The Morecambe Offshore Windfarm Generation Assets

Written Representation of Spirit Energy Production UK Limited

EN010121
Unique Reference: 20049981

Date	26 November 2024
-------------	------------------

Figure 7A

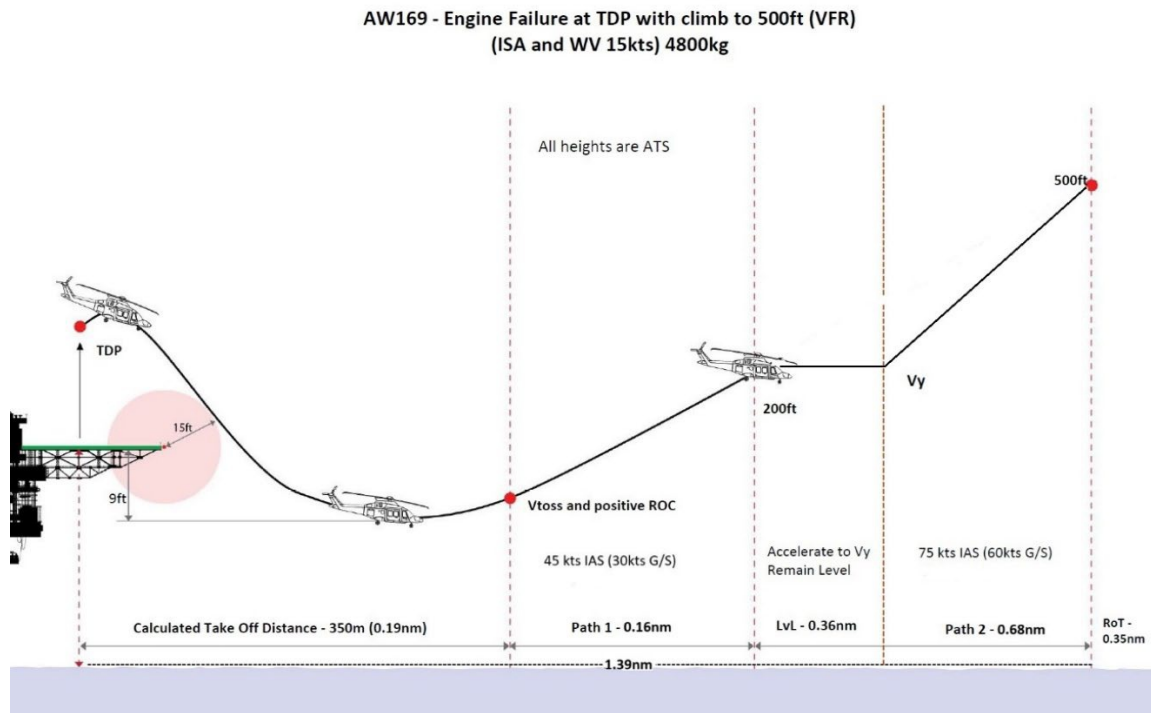
2.14.2 For departure: accommodate an engine failure on departure from a helideck, accommodate an OEI climb to 500 feet in VFR as well as the turn away from the turbine array. See Figure 7A of the Updated AviateQ Report.

Figure 8
Plan View of Distance Required to establish VFR onto an Approach to a Facility Adjacent to a Wind Farm Array (80 kts / Rate 1 Turn) and in a fully Stabilised Configuration

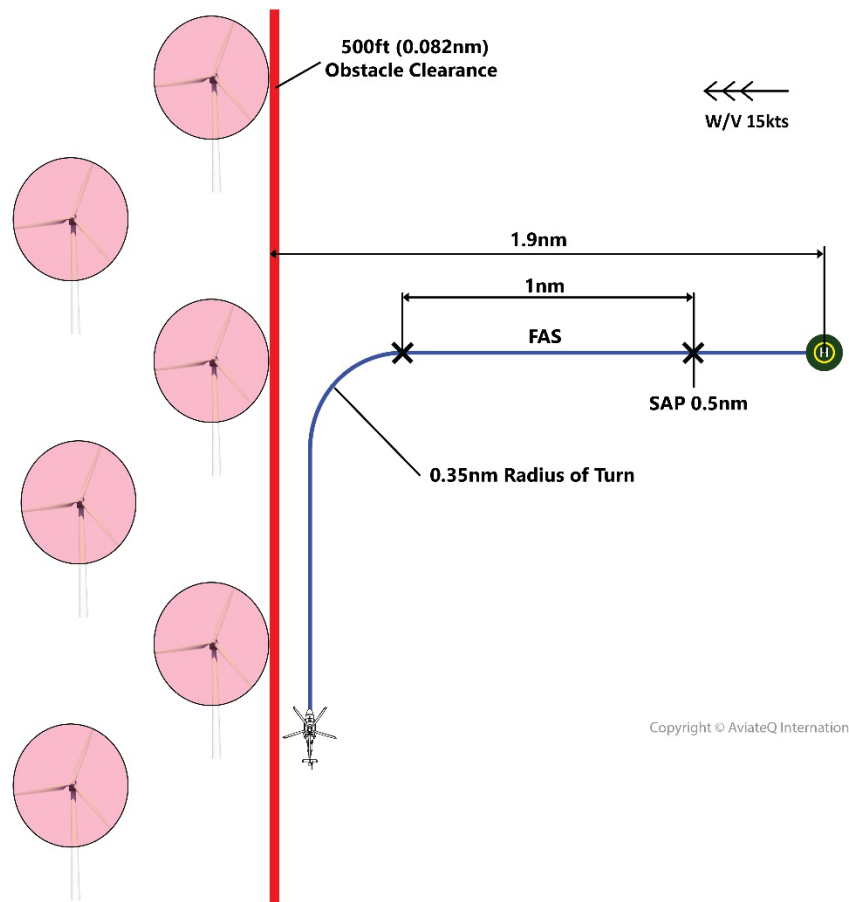
2.14.1 For arrival: ensure the helicopter positioning into the wind onto the Final Approach Sector and thereafter performing a stabilised landing onto the helideck. See Figure 8 of the Updated AviateQ Report.

Figure 14A
AW169 Profile View Distance Required OEI Climb to 1,000ft

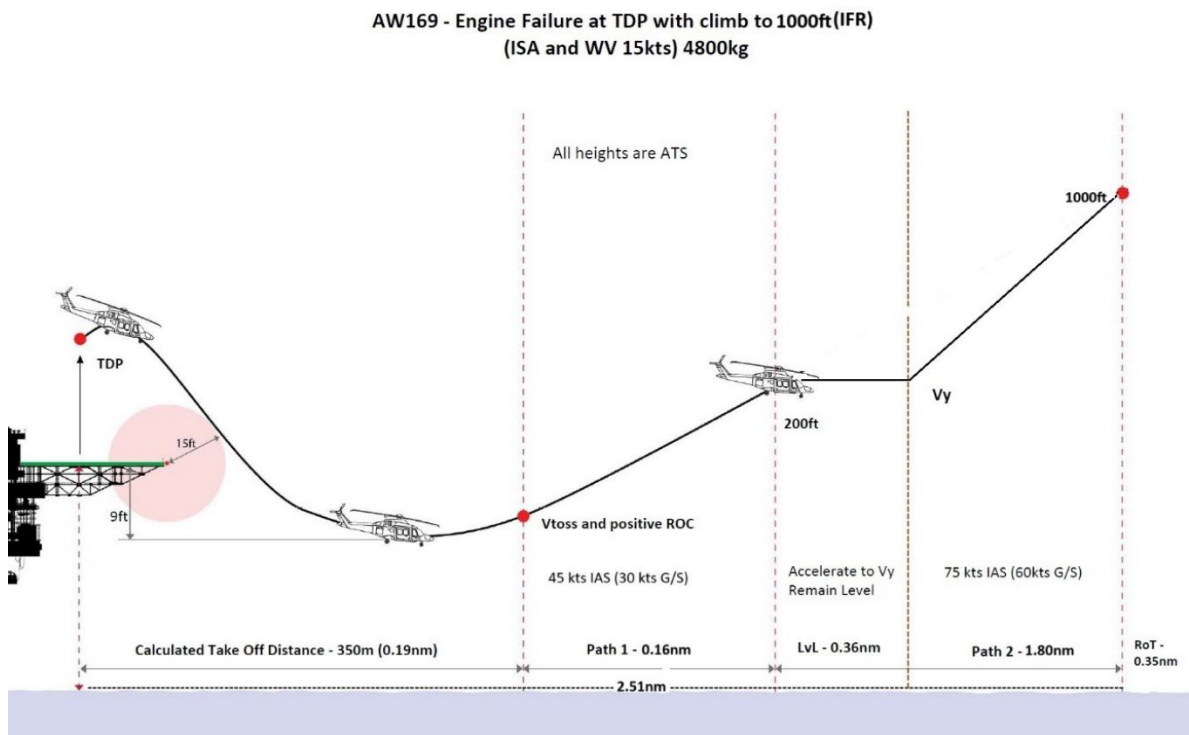
- 2.11 The Examining Authority is directed to Figure 14A of the Updated AviateQ Report (extracted below). The Examining Authority is also directed to pages 26 to 28, and page 31, of the Updated AviateQ Report for further technical justification.

2.12 This figure summarises the AW169 profile distance requirements for OEI take off with climb to 1000 feet. The figure does not take into account a rate one turn distance of 0.35nm and 1nm legal obstacle clearance requirement which must be added to the profile distance of 2.51nm noted above. The total calculated unobstructed airspace when operating in IFR must be **at least 3.86nm**.
